Subject: Serial 1-1274 - Supplemental Information in Response to NRC Question Number24 on the Preliminary Probable Cause Summary Report dated March 22, 2002

Mr. J. E. Dyer, Administrator
United States Nuclear Regulatory Commission
Region III
801 Warrenville Road
Lisle, IL 60532-4351Subject: Supplemental Information in Response to NRC Question Number 24 on
the Preliminary Probable Cause Summary Report dated March 22, 2002

On April 30, 2002, Davis-Besse Nuclear Power Station, Unit 1 (DBNPS) submitted to the NRC letter Serial Number 1-1272, "Responses to NRC Questions on the Preliminary Probable Cause Summary Report dated March 22, 2002" regarding the Reactor Pressure Vessel (RPV) head degradation. The purpose of this letter is to provide the NRC with supplemental information on crack profiles for significant cracks on nozzles 2 and 3, as discussed in the response to question number 24 of the aforementioned letter.

Figure 9. Nozzle 2 Crack Locations and Sizing

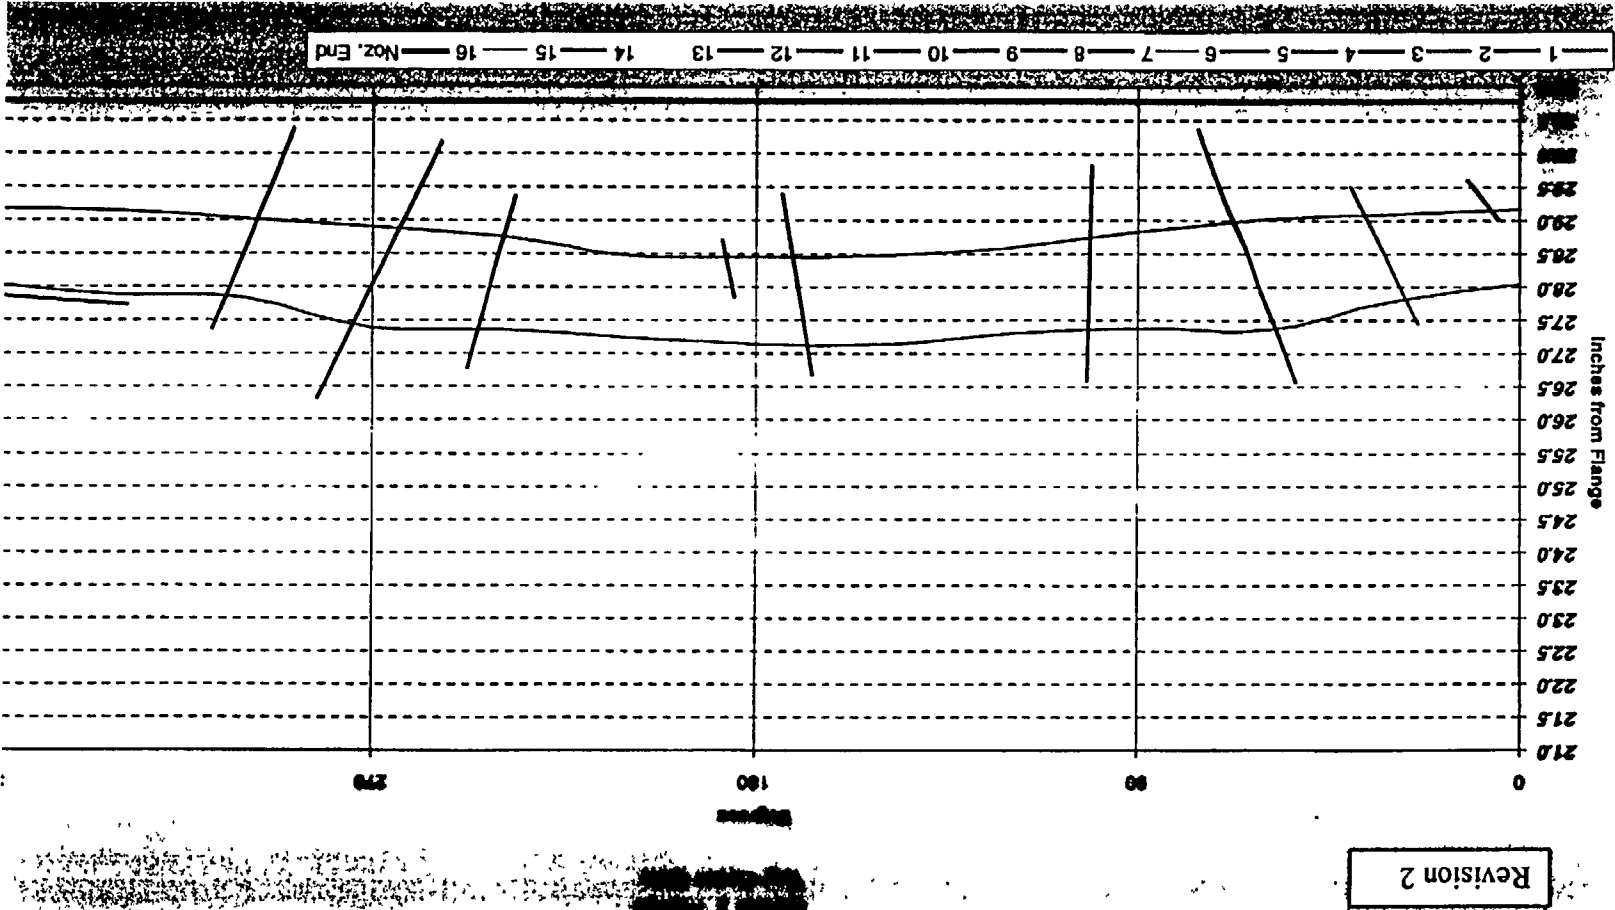
In addition, a revised ultrasonic examination data sheet and top-down profile are enclosed for nozzle 2, which includes the recently added flaw 13 that was discussed with the NRC during the May 7, 2002 Root Cause Analysis Meeting. Flaw 13 was not identified in the Root Cause Analysis Report, which was submitted to the NRC on April 18, 2002 by letter Serial Number 1-1270, therefore, the enclosed revision to Table 2 and Figure 9 are provided to update that report. A Condition Report has been generated to evaluate the omission of flaw 13 from the Root Cause Analysis Report.
